# ***ASHLAND/NORTHERN STATES POWER LAKEFRONT SUPERFUND SITE***

## ***ASHLAND, WISCONSIN***

***Constructability Review -- Re: EPA Proposed Plan (June 2009)  
August 17, 2009***

***Prepared for:  
Northern States Power Wisconsin  
Minneapolis, MN***

# Constructive Input of Dry Dredge USEPA Remedy Selection

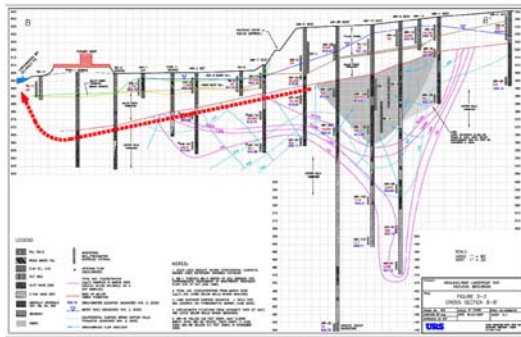
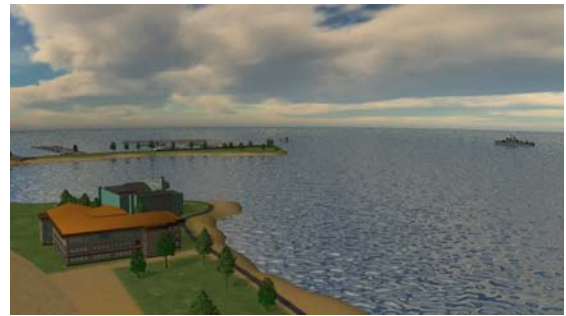
10 No. 2, we will also have upwelling in  
11 the dredging area itself. And the upwelling is  
12 what we are really going to focus on right now,  
13 and we have a short animation that we want to  
14 show you that shows you what could happen under  
15 dry dredge conditions if there was upwelling and  
16 basically potential failure of the sheet pile  
17 wall.

1 So with that, we're going to show you an  
2 animation and show you what we think is going to  
3 happen.

FIGURE 1

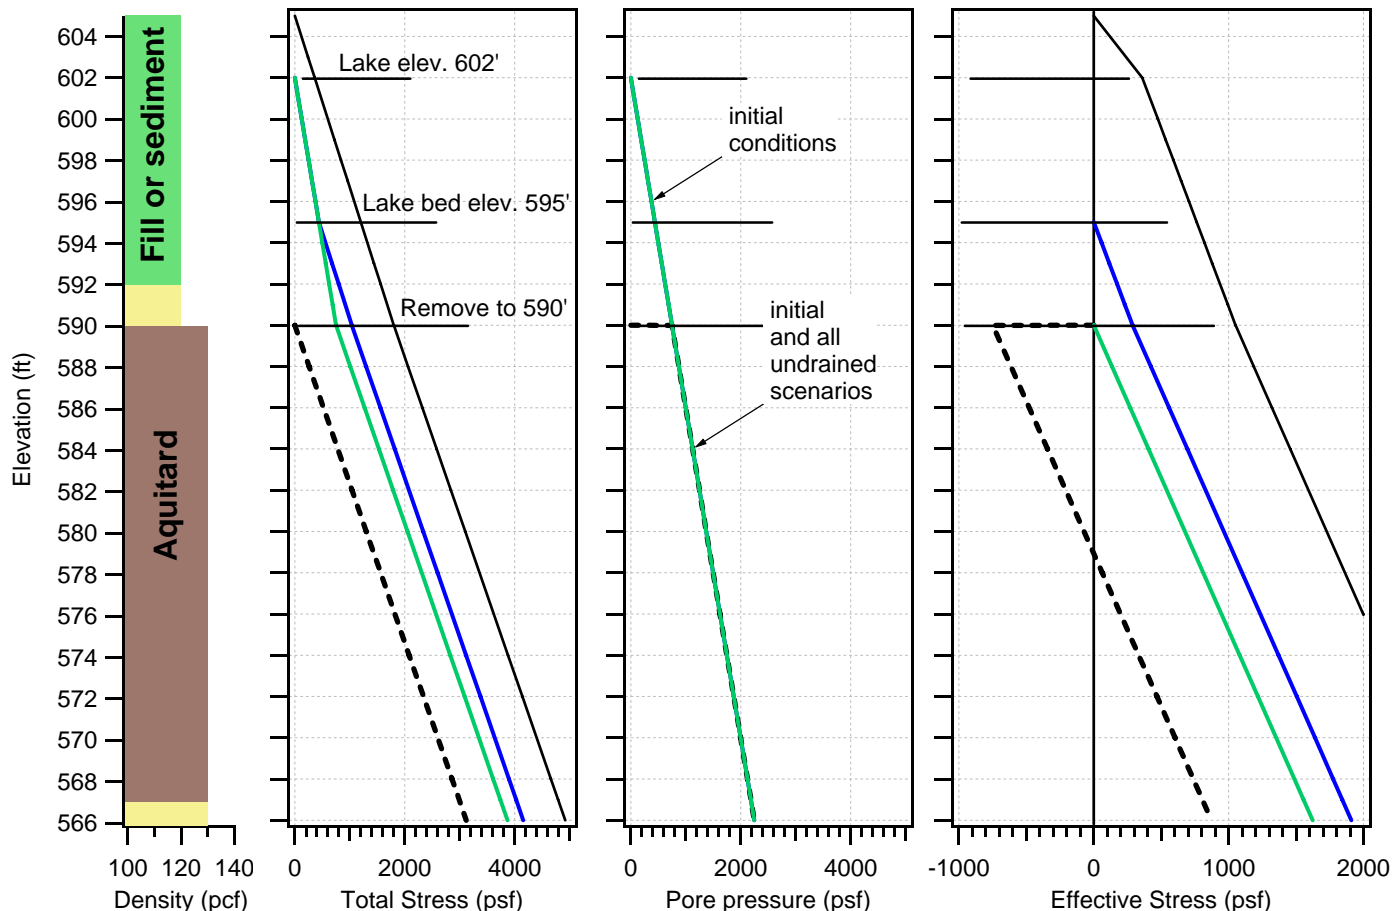
the pore pressure provided by the artesian head. The assumed geologic profile, total stresses and pore water pressures are shown in Figure 1.

1. Assumes artesian conditions at base of aquitard.  
Head = 617.1 ft.  
pore water pressure = (62.4 pcf) (617.1 - 567 ft) = 3126 psf.
2. Assumes initial pore pressures in aquitard are in equilibrium.
3. Undrained cases assume that pore pressures in aquitard do not change.

FIGURE 2

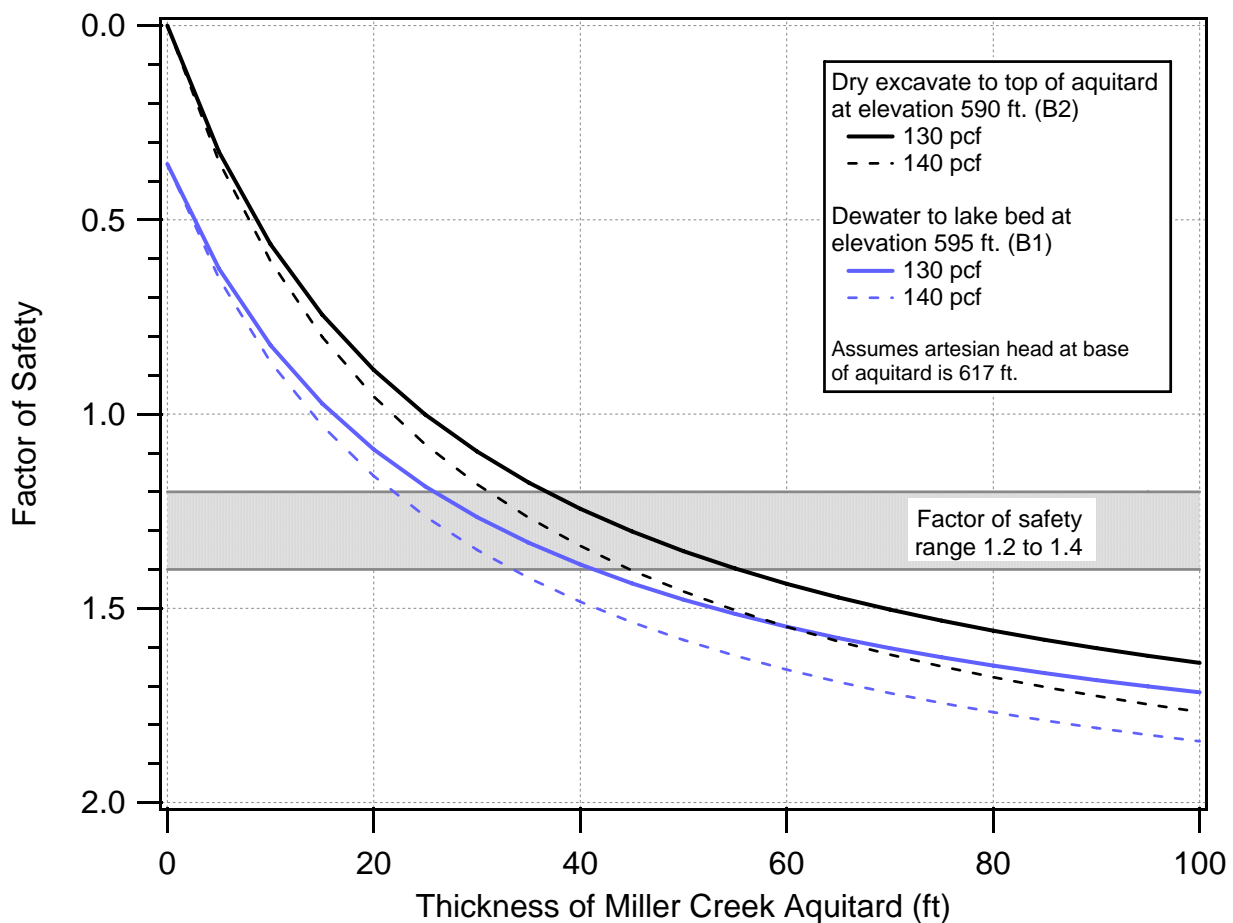
As mentioned above, the result of a negative effective stress at the top of the aquitard for the hybrid removal option is not unexpected. This result would occur even without artesian conditions, as is shown in Figure 2. Here, the head at the base of the aquitard is set at the lake elevation, and the pore pressure at the base of the aquitard is 2184 psf, nearly 1000 psf lower than the artesian condition. The effective stress at the top of aquitard is the same (-750 psf), but effective stresses increase to positive values at depth within the aquitard.

1. Assumes artesian conditions removed at base of aquitard.  
Head = 602 ft.  
pore water pressure = (62.4 pcf) (602 - 567 ft) = 2184 psf.
2. Assumes initial pore pressures in aquitard are in equilibrium.
3. Undrained cases assume that pore pressures in aquitard do not change.

FIGURE 3

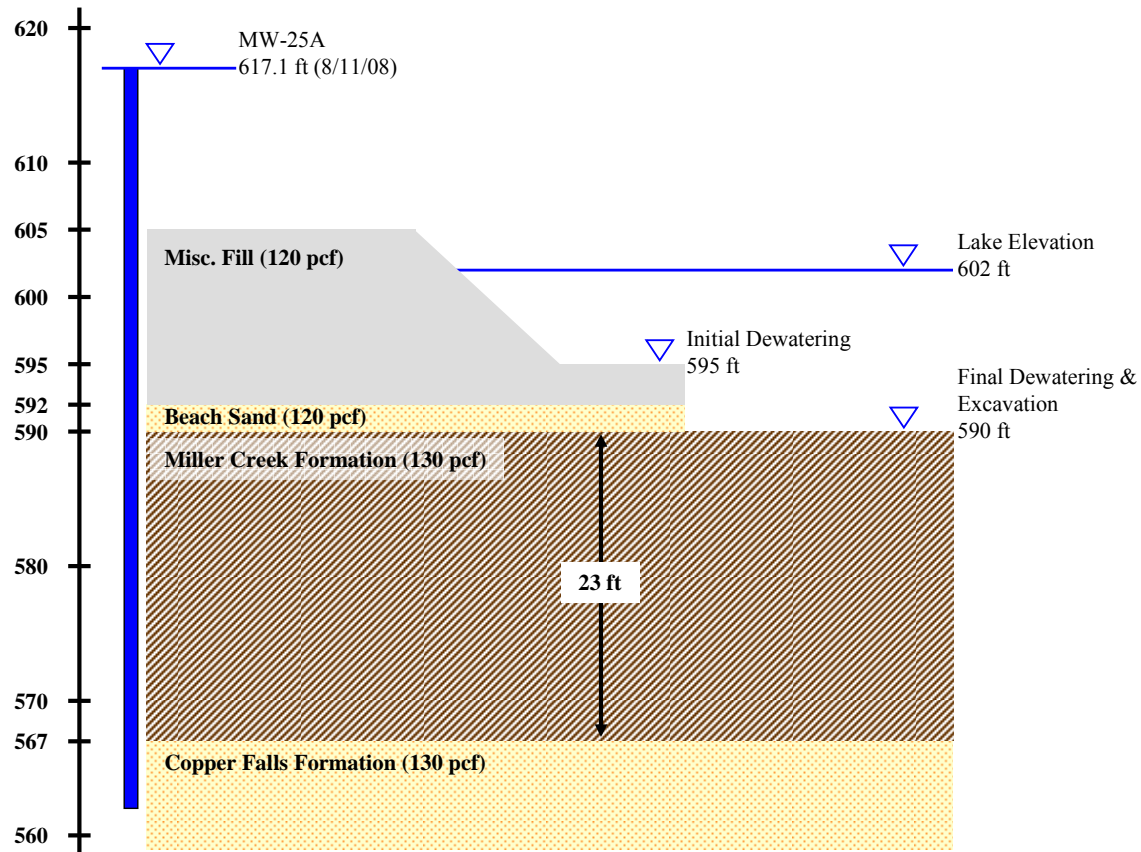
The factor of safety against basal heave failures was calculated for various values of aquitard thickness and unit weights (sediment and aquitard density) and plotted by AECOM. With the factor of safety defined as the ratio of the overburden stress to the porewater pressure at the base of the aquitard, Foth has reproduced the calculations and plotted curves for the same conditions. The result is shown in Figure 3. The overall agreement between the Foth calculations and the AECOM plot is good.

- Analysis does not consider resistance to basal heave due to shear strength of aquitard clay, and it ignores geometric effects of potential failure surfaces. Analysis should be considered as preliminary.
- Other failure mechanisms not considered here, such as from piping.
- Figure is an independent analysis and check of analysis provided by AECOM, received by Foth on 5/21/09. The agreement is excellent.
